TXDOT AVIATION STATEWIDE AIRPORT ELECTRICAL CONSTRUCTION PROJECT (AVSAE) - GROUP ALPHA
TxDOT CSJ No. 4222AVSAEA

ADDENDUM NO. 3

May 14, 2025

1 / ET4.1 **VAULT SITE PLAN**

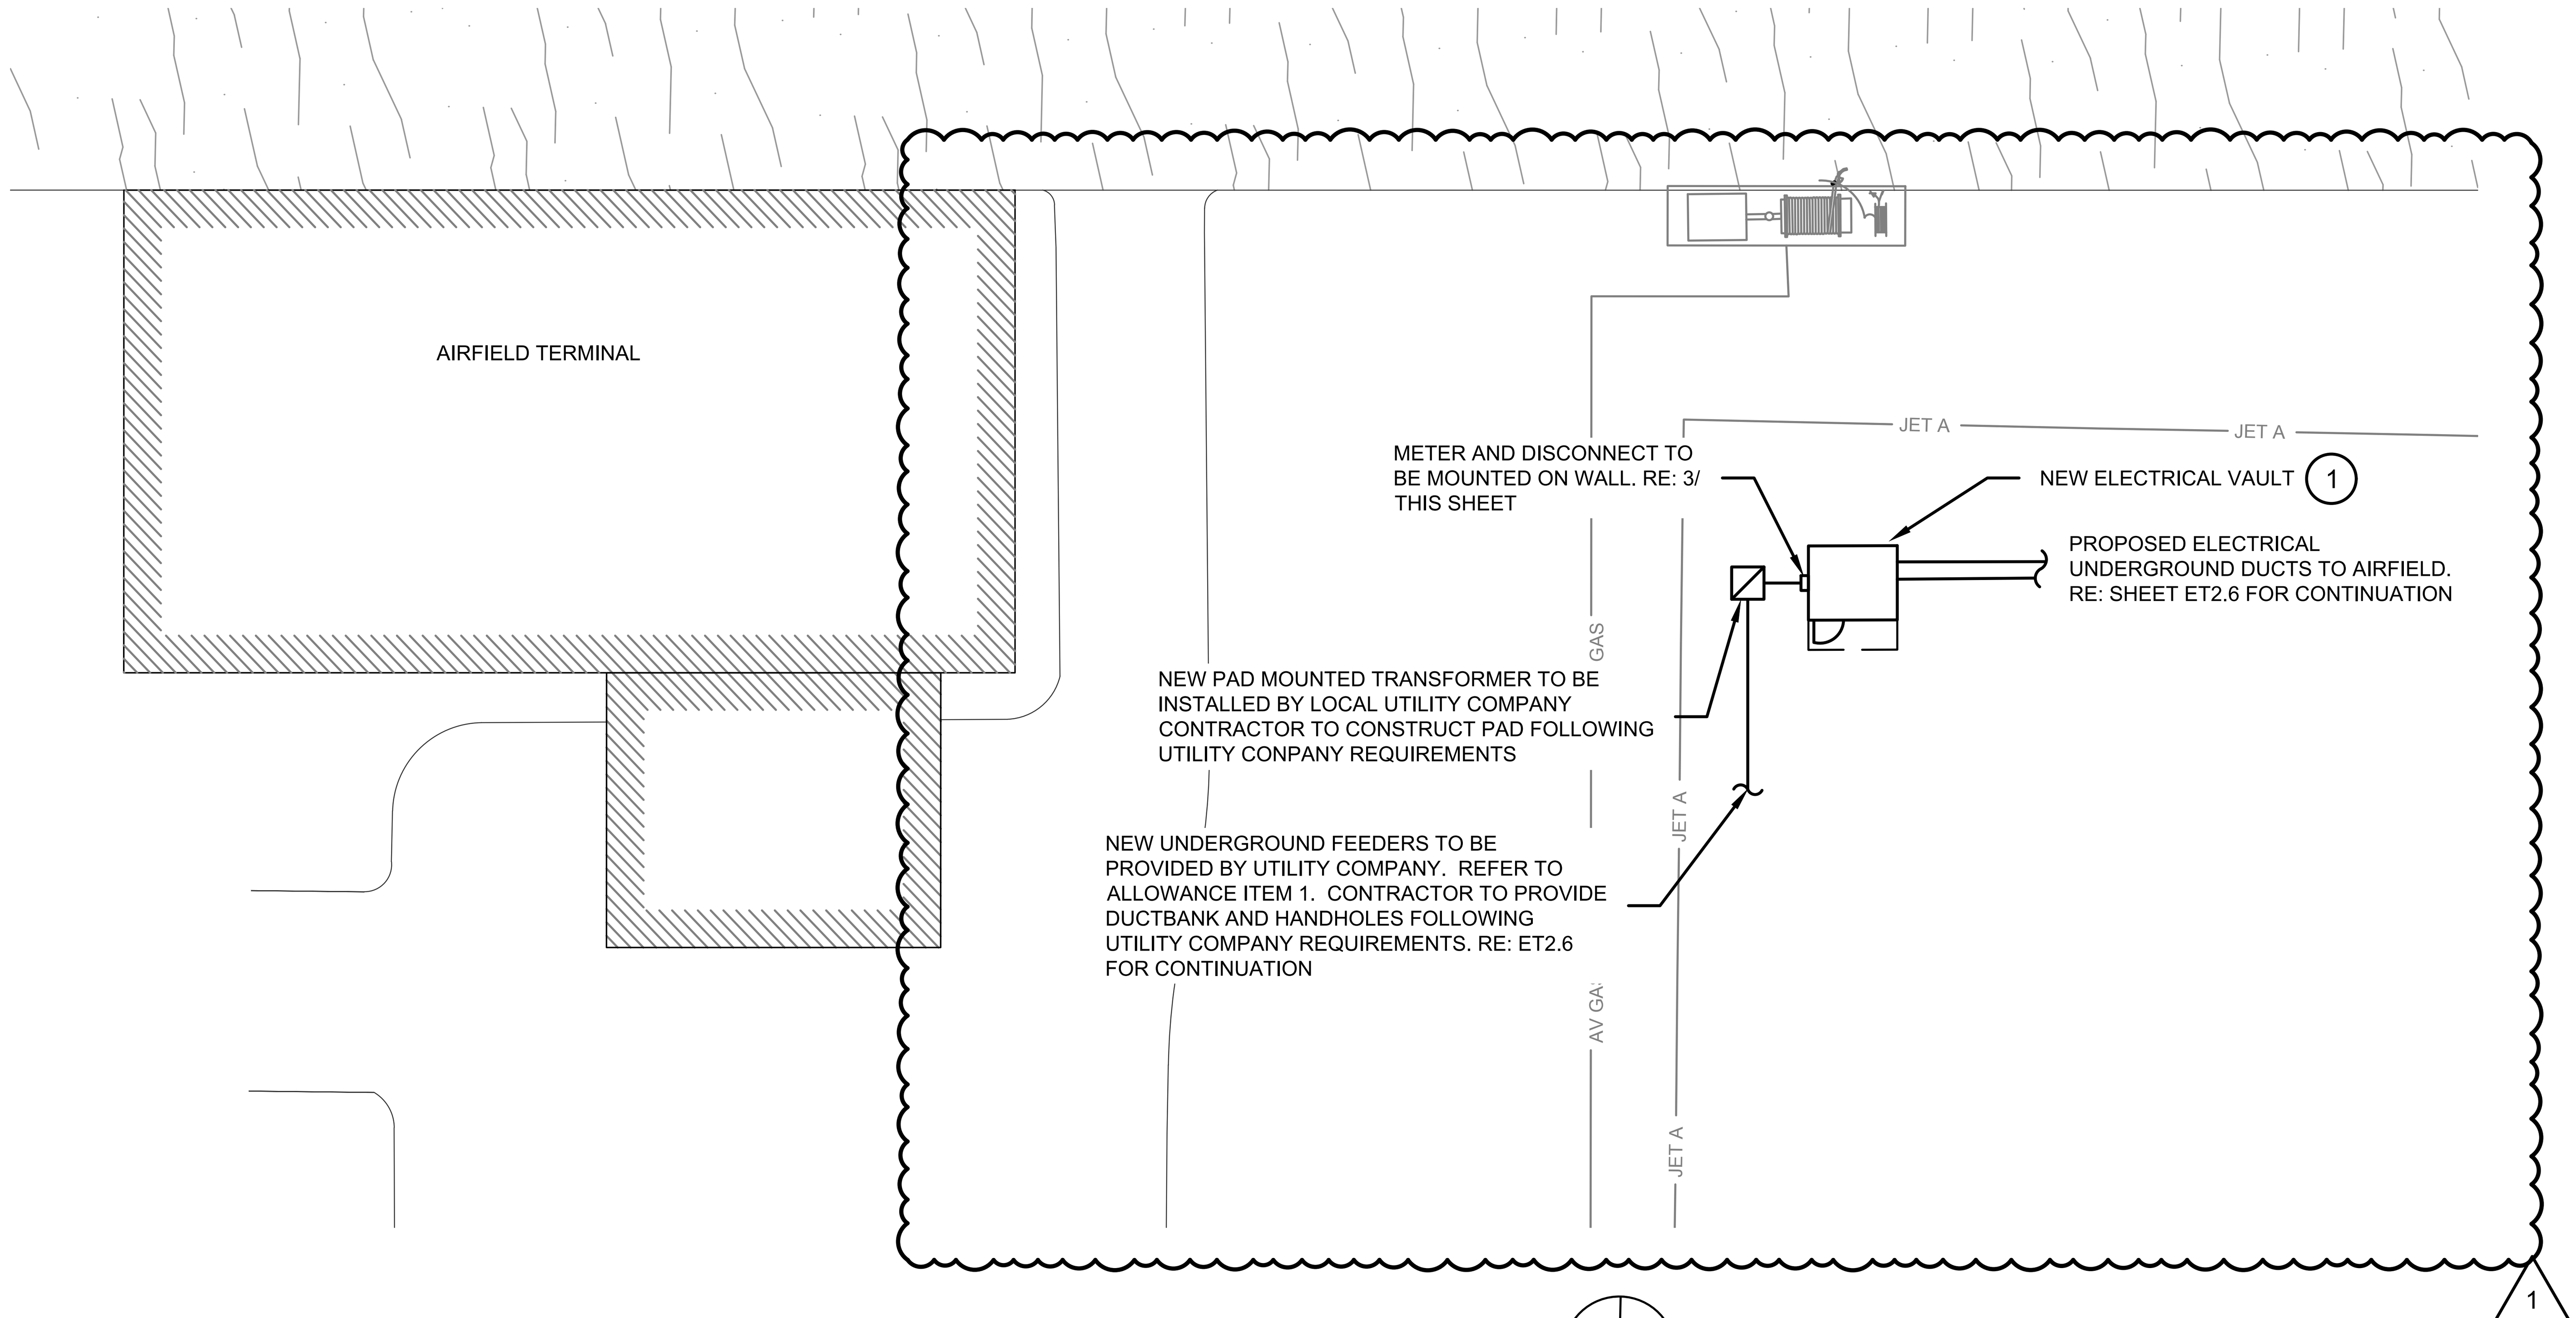
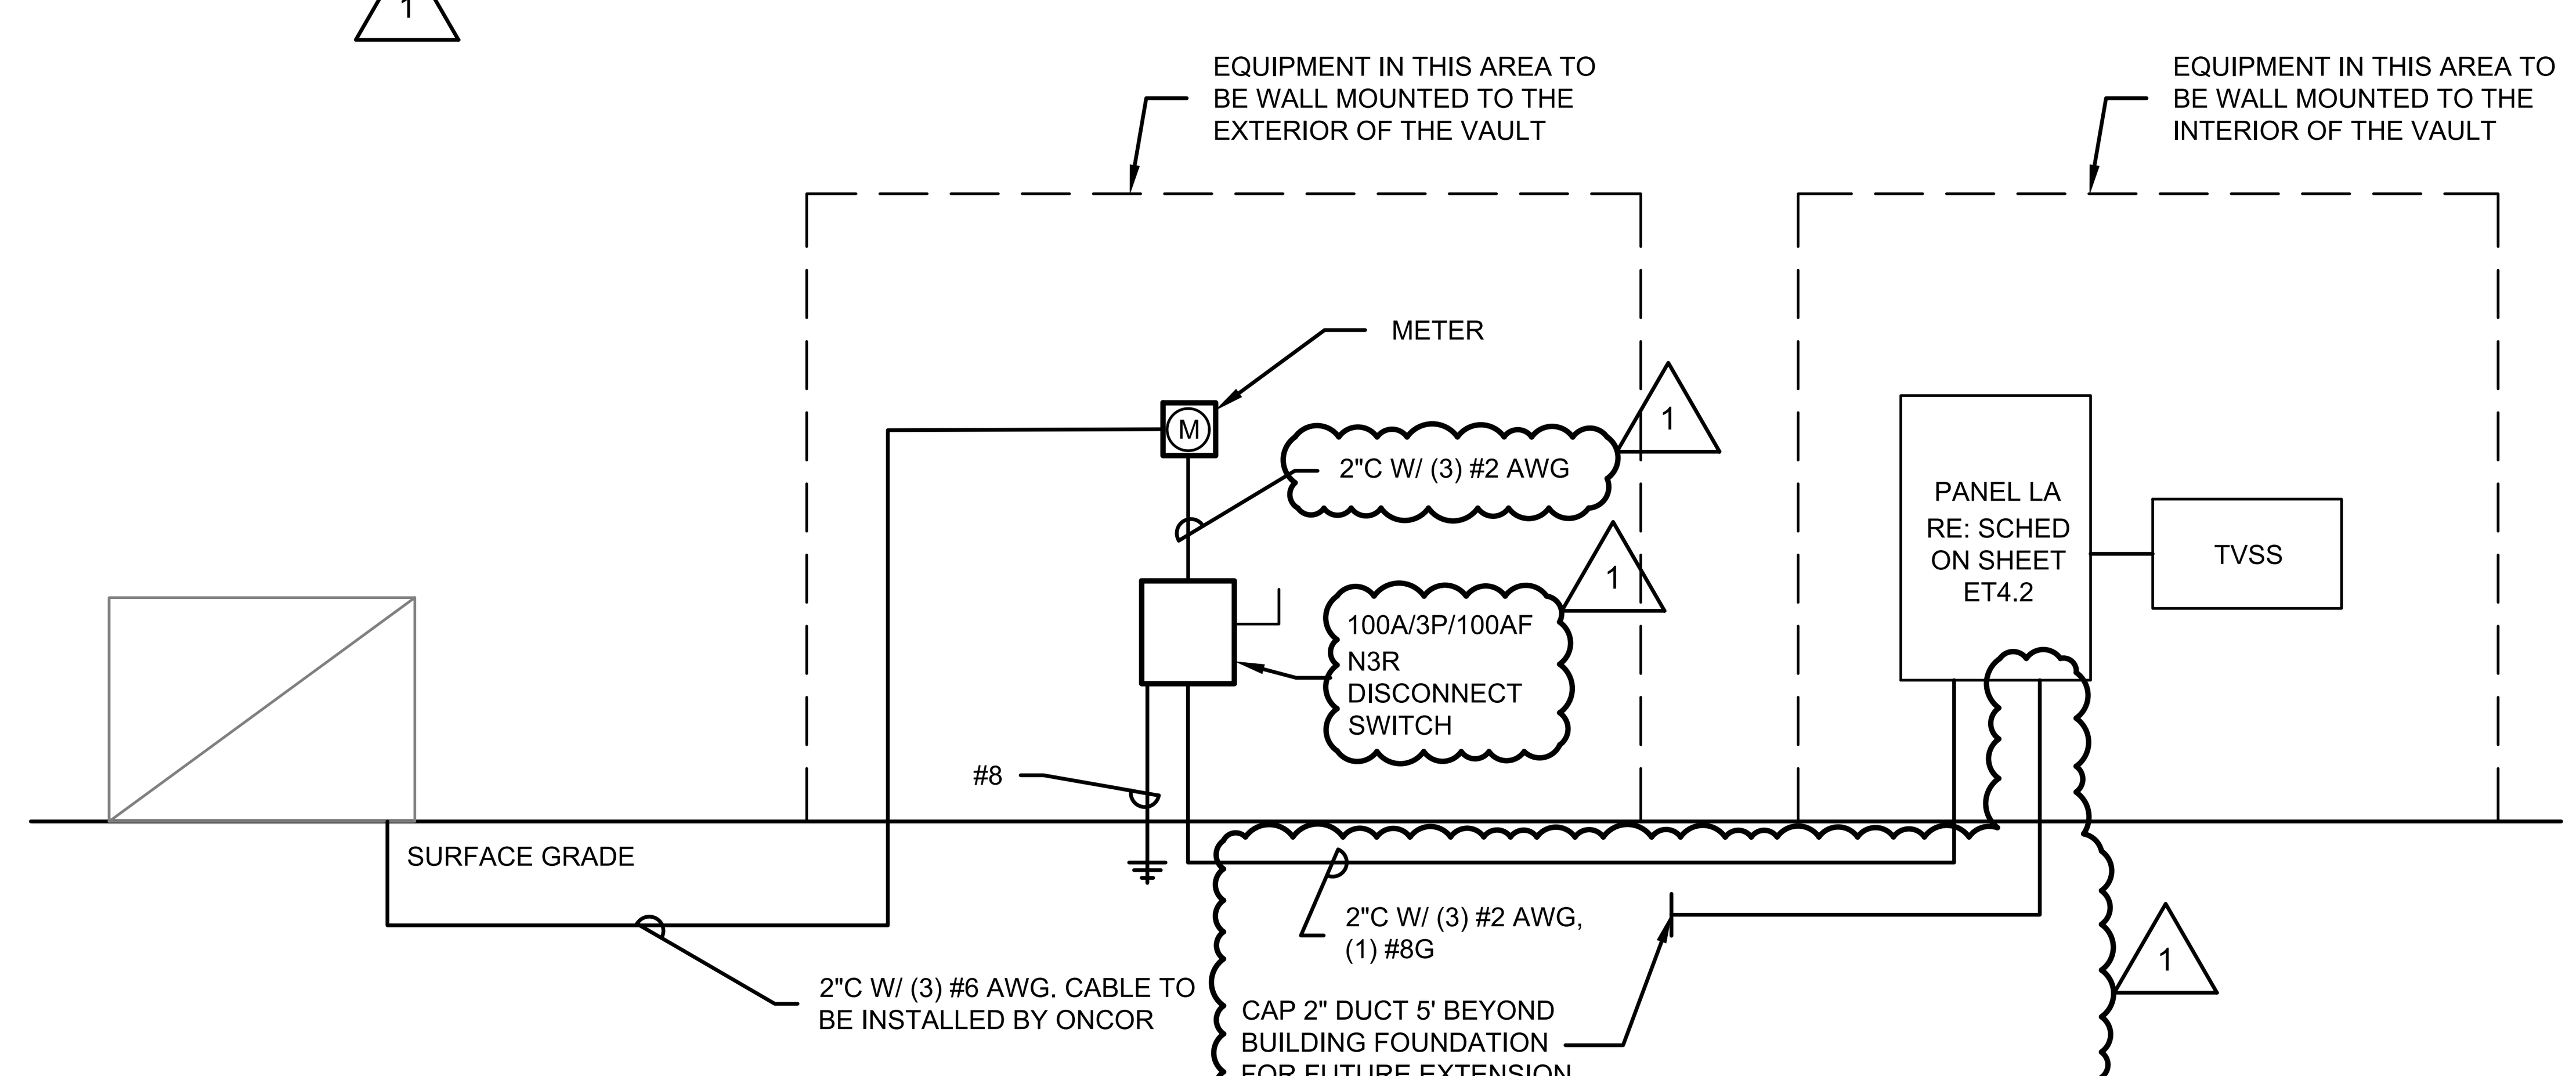
rrr) Sheet ET4.1 – Electrical Vault Plan. Revised detail 1 to clarify service entrance scope. Revised keyed note 1 to clarify HVAC system requirements. Revised detail 2 to clarify vault exterior profile view and plan view. Updated detail 3 to clarify one line diagram callouts.
